CALL NO. 102
CONTRACT ID NO. 161061
ADDENDUM # 2

Subject: Ohio County, NHPP 0031 (011)
Letting December 9, 2016

DESCRIPTION WILLIAM NATCHER PARKWAY(PW-9007)

REVISED ADDENDUM #2: 12-5-16

SPECIAL NOTE FOR REPLACING COMPRESSION SEAL IN EXISTING EXPANSION JOINT

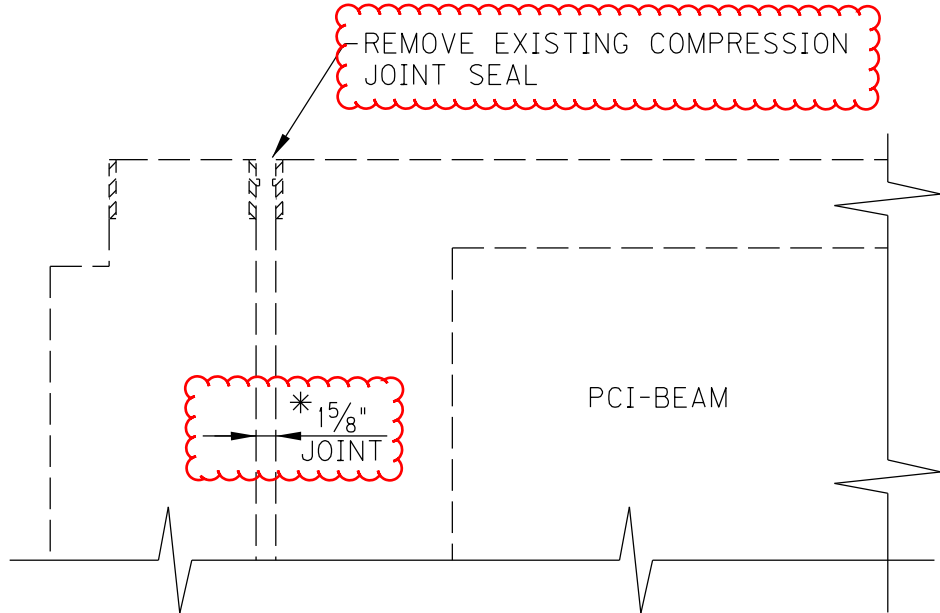
- (1) Revised - Front Sheet
- (2) Revised - Completion Date - Page 4 of 407
- (3) Revised - Typical Section - Page 22 of 407
- (4) Revised - Pavement Summary - Page 24 of 407
- (5) Revised - Pavement Areas - Page 25 of 407
- (6) Revised - Guardrail Summary - Pages 67-68 of 407
- (7) Revised - Base Failure Repair Details - Page 128 of 407
- (8) Revised - Traffic Control Plan - Page 132 of 407
- (9) Revised - Special Note for Fixed Completion Date - Page 164 of 407
- (10) Revised - Special Note - Pages 200-201 of 407
- (11) Revised - Drawing Replace Seal - Pages 225 & 232 of 407
- (12) Revised - Bid Items - Pages 402-407 of 407

3.1. Remove Existing Materials. Remove the existing compression seal as shown on the attached sketches. Remove debris and/or expansion joint filler as directed by the Engineer. Dispose of all removed material entirely away from the job site. This work is incidental to the contract unit price for "Expansion Joint Seal Replacement".

3.3. Pre-Compressed Horizontal Expansion Joint System. System shall be supplied in pre-compressed sticks for easy installation. System shall be installed in accordance with manufacturer's recommendations concerning approved adhesives, welds between sticks and appurtenances, and adhesion to concrete deck or armored edges. Joint seal is to be installed ½" recessed from the surface. The joint system used shall be equivalent to the joint system manufactured by *EMSEAL Joint Systems, Ltd.*
